VL2600 Series

TECHNICAL NOTICE	
Product	VL2600 PROFILE, VL2600 WASH, VL2600 SPOT
Subject	TN - 01788

Updated firmware for the following fixtures

Calibration Setup

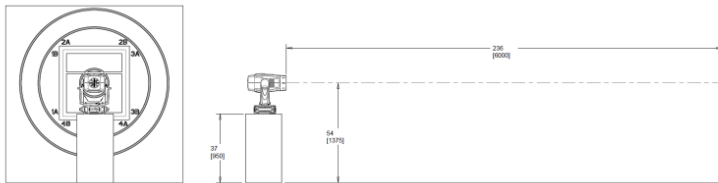
Option 1 – Reset using the Target Diagram as shown below.

- Fixture positioned 6 meters from wall
- Wall to be marked with Figure on the next page.
- When pointing at wall, center of lens should be the same distance from the floor as center of circles

- **Once you have the fixture in position, update the software to 083019.** Then, reset the pan and tilt offsets to 0. "Menu -> Service -> Service Settings -> Pan Offset -> 'UP or DOWN' until it reads 0 -> 'ENTER'". Repeat for 'Tilt Offset'. **DO NOT RESET ALL OFFSETS!**
- Power cycle fixture
- Perform offset using the values for pan/tilt as described

Calibration Setup (continued)

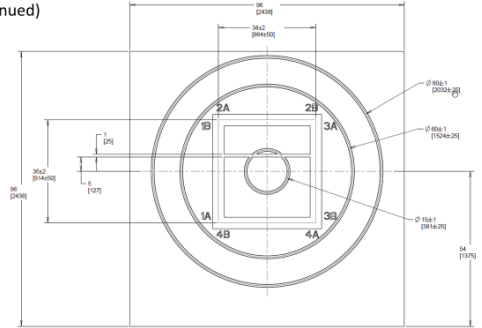
- Dimensions are inches +/- tolerance [mm +/- tolerance]
- Ø means diameter

04-2600-0001_DXF.dxf is a scaled file that can be printed on a sign. It will be 8 feet tall by 8 feet wide (96" x 96")

When the bottom of this image touches the floor, the bench that the VL2600 sits on should be 37 inches tall

1. Set Pan & Tilt Offsets Profile, Spot, Wash

Offset Function	Function Settings	DMX Value (8bit/8bit)
Pan & Tilt	Pan	128/0
	Tilt	44/41
	Zoom	127/238
	Edge	216/114
	Iris	255

This setting closes the iris and allows you to set pan & tilt offsets to line up to the center circle. This will insure that the VL2600 is projecting normal to the measurement wall.
